To: T10 Technical Committee  
From: Rob Elliott, HP (elliott@hp.com)  
Date: 16 July 2008  
Subject: 08-283r1 SAS-2 SNW-3 SATA port selector confusion

**Figure 151 — SAS speed negotiation sequence (phy A: SNW-3 only, phy B: SNW-1 only)**

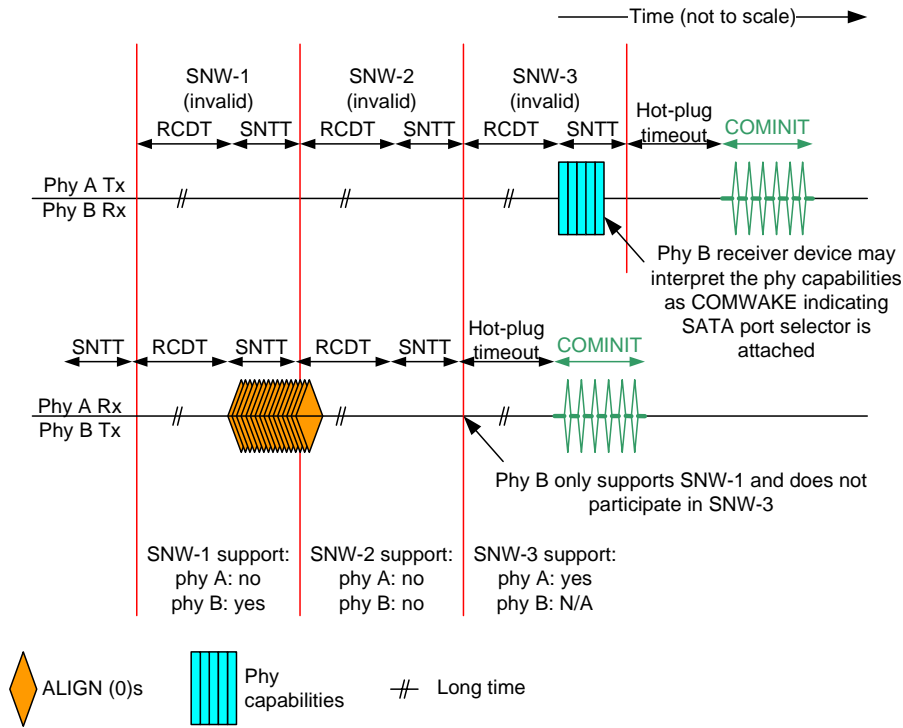
Since a phy capabilities bit set to one is defined as COMWAKE (see table 97 in 6.7.4.2.3.3), phy B interprets the first phy capabilities bit set to one from phy A as being a COMWAKE in response to its COMINIT during the OOB sequence. This falsely identifies a SATA port selector and causes phy B to incorrectly set its ATTACHED SATA PORT SELECTOR bit to one in the SMP DISCOVER response (see 10.4.3.10).

When phy B transmits COMINIT during SNW-1 of the next OOB sequence, phy A detects that a SAS phy is attached, not a SATA phy, and sets the ATTACHED SATA PORT SELECTOR bit to zero in the SMP DISCOVER response. However, the phys may keep repeating this process after each hot-plug timeout.

An expander device originates Broadcast (Change) whenever the ATTACHED SATA PORT SELECTOR bit changes from zero to one (see 7.12), so this results in Broadcast (Changes) at hot-plug timeout intervals.

Figure 152 — SAS speed negotiation sequence SNW flowchart [\[changed\]](#)

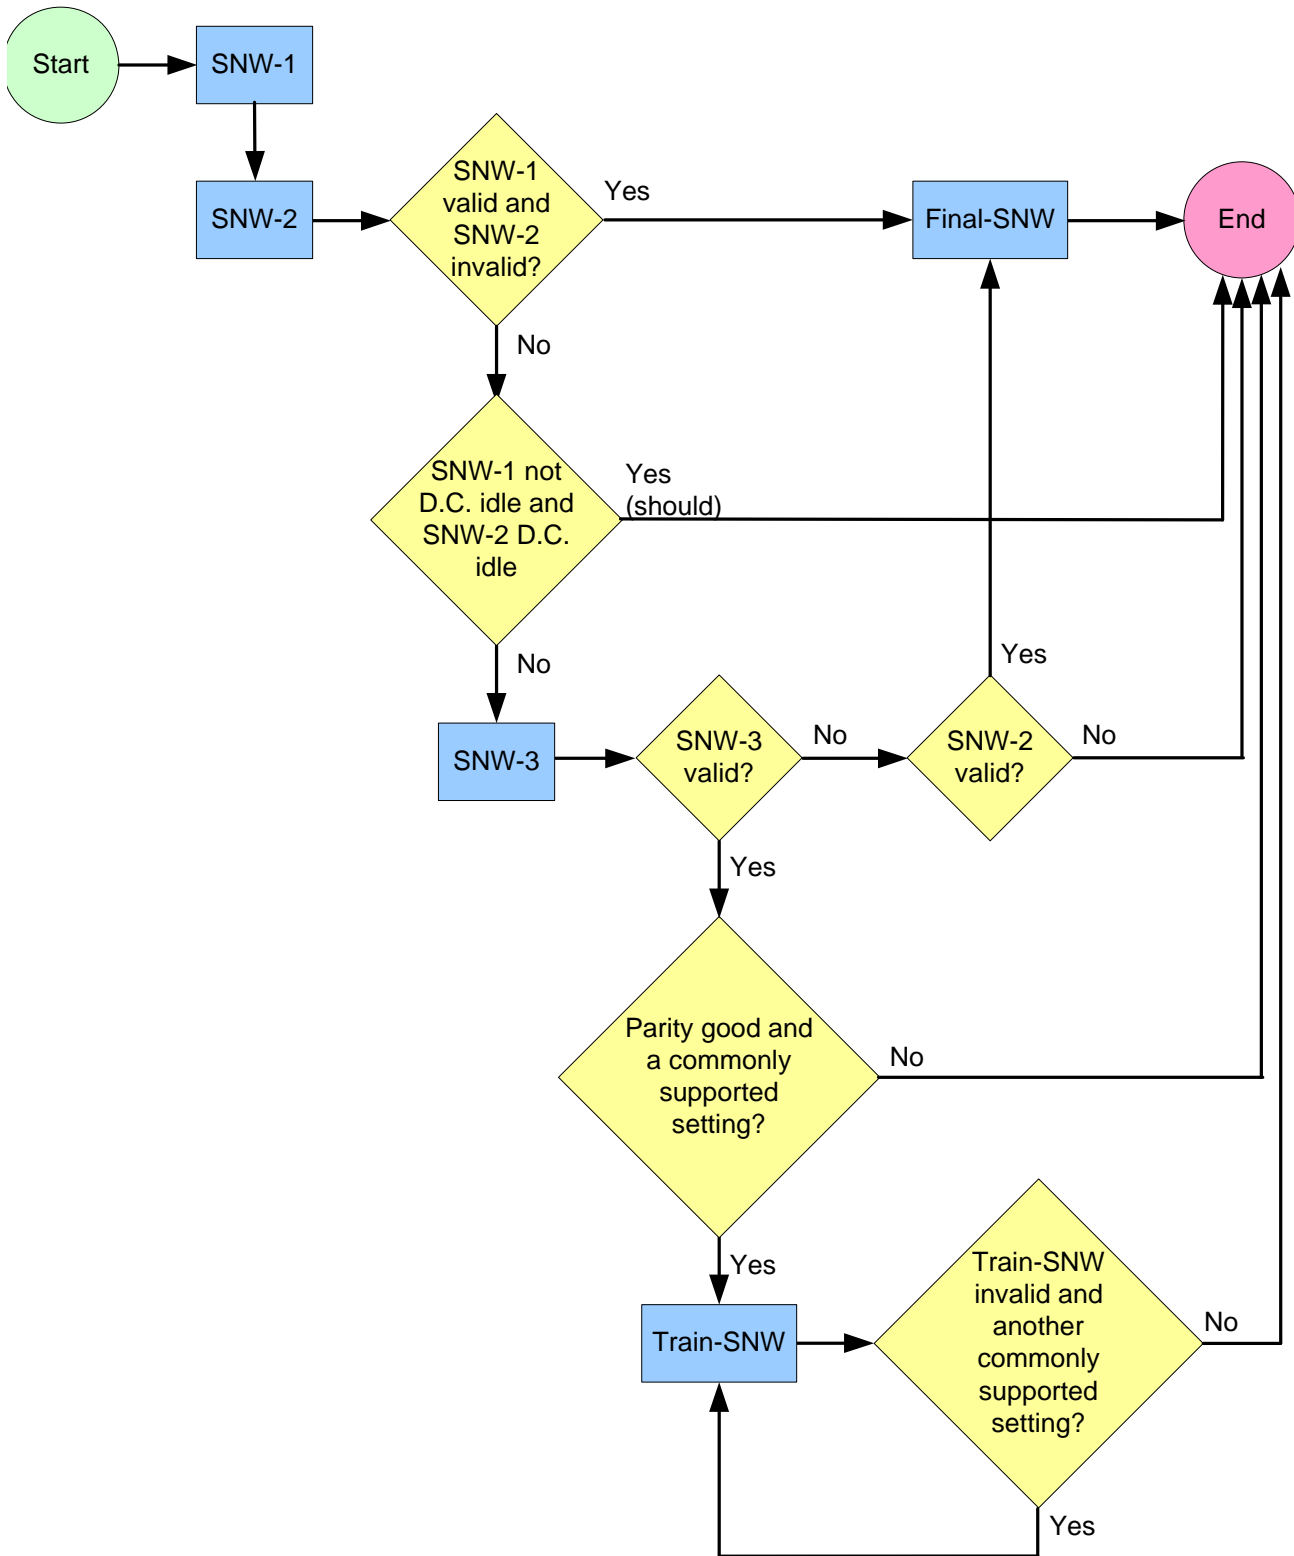
Editor's Note 1: Note that if SNW-1 and SNW-2 are both invalid, a SAS-2 phy still sits through SNW-3. It only skips SNW-3 if SNW-1 is valid and SNW-2 is invalid.

A phy shall not support the following combinations of supported SNWs:

- a) no SNWs; and
- b) SNW-1 and SNW-3 only.

NOTE 1 - If SNW-1 is successful and the combination of SNW-1 and SNW-3 only is used, then the phy is not able to reach SNW-3.

A phy should detect whether the physical link is D.C. idle during SNW-1 and SNW-2, even if the phy does not support that SNW. If the phy detects:

- a) SNW-1 is not D.C. idle; and
- b) SNW-2 is D.C. idle,

then it should end the speed negotiation sequence without progressing to SNW-3.

NOTE 2 - This avoids causing an attached phy compliant with a previous version of this standard to misdetect a SATA port selector.

**Figure 151 — SAS speed negotiation sequence (phy A: SNW-3 only without D.C. idle detection, phy B: SNW-1 only) [no changes]**

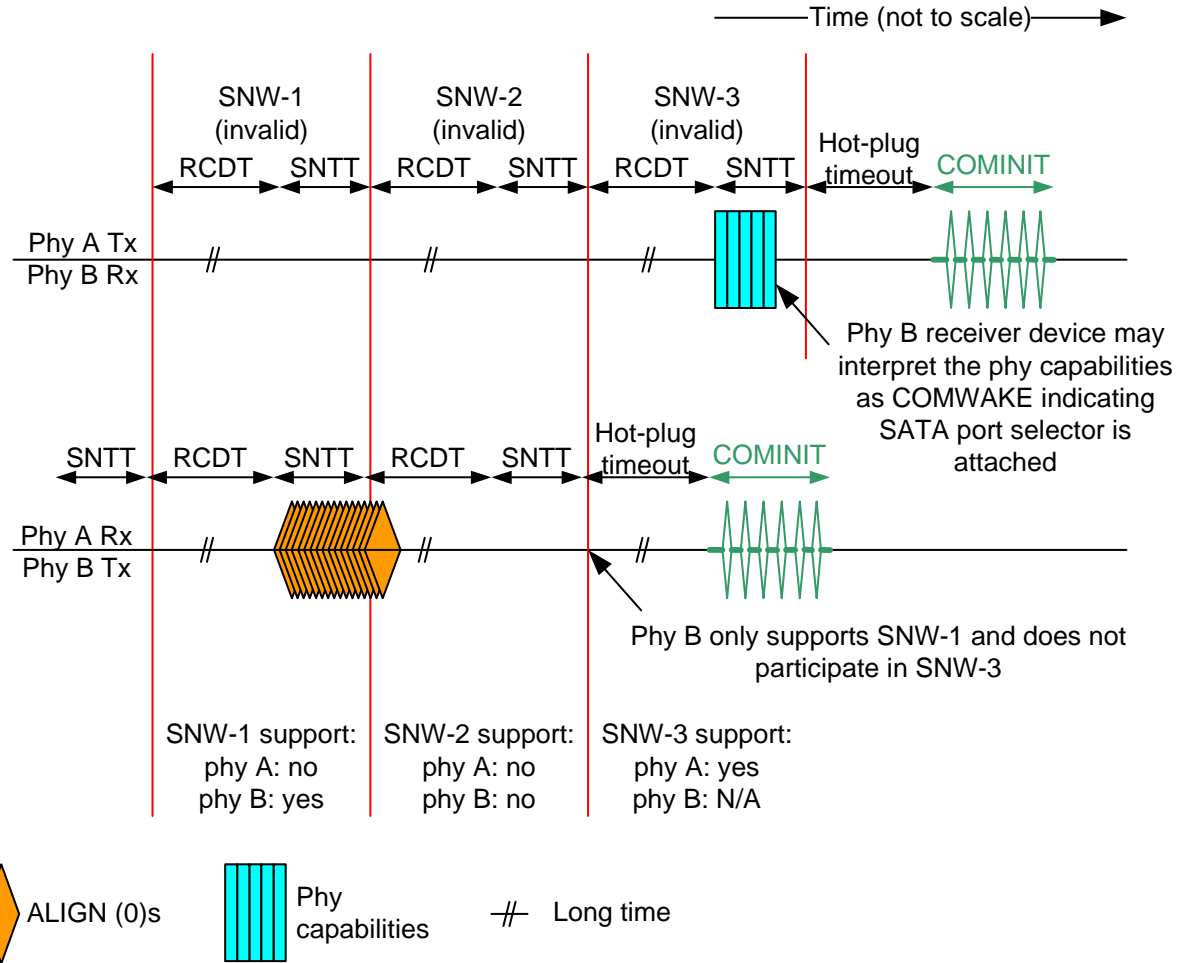
If phy A does not follow the recommendation to detect D.C. idle described in 6.7.4.2.4, then phy **Phy** A proceeds to SNW-3 while phy B returns to the OOB sequence.

Since a phy capabilities bit set to one is defined as COMWAKE (see table 97 in 6.7.4.2.3.3), phy B interprets the first phy capabilities bit set to one from phy A as being a COMWAKE in response to its COMINIT during the OOB sequence. This falsely identifies a SATA port selector and causes phy B to incorrectly set its ATTACHED SATA PORT SELECTOR bit to one in the SMP DISCOVER response (see 10.4.3.10).

When phy B transmits COMINIT during SNW-1 of the next OOB sequence, phy A detects that a SAS phy is attached, not a SATA phy, and sets the ATTACHED SATA PORT SELECTOR bit to zero in the SMP DISCOVER response. However, the phys may keep repeating this process after each hot-plug timeout. An expander device originates Broadcast (Change) whenever the ATTACHED SATA PORT SELECTOR bit changes from zero to one (see 7.12), so this results in Broadcast (Changes) at hot-plug timeout intervals.
